Proposed Changes to Clause 45 MDIO Registers for 1000BASE-T1

May 18, 2015

Mike Tu

Table 45-7—PMA/PMD control 2 register bit definitions

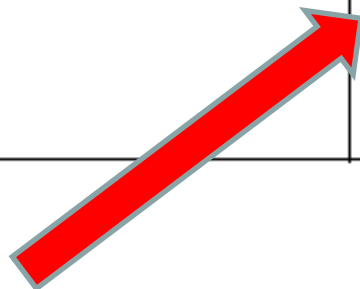
Replace indicated line in the 1.7.5:0 row of Table 45-4 with five new lines, as follows (unchanged lines not shown):

Redefine 111101 = BASE-T1 PMA/PMD

Bit(s)	Name	Description	R/W ^a
1.7.5:0	PMA/PMD type selection	5 4 3 2 1 0 1 1 x x x x = reserved for future use 1 1 1 1 1 x = reserved for future use <u>1 1 1 1 0 1 = 100BASE-T1 PMA/PMD</u> 1 1 1 1 0 0 = reserved for future use 1 1 1 0 x x = reserved for future use 1 1 0 x x x = reserved for future use	R/W
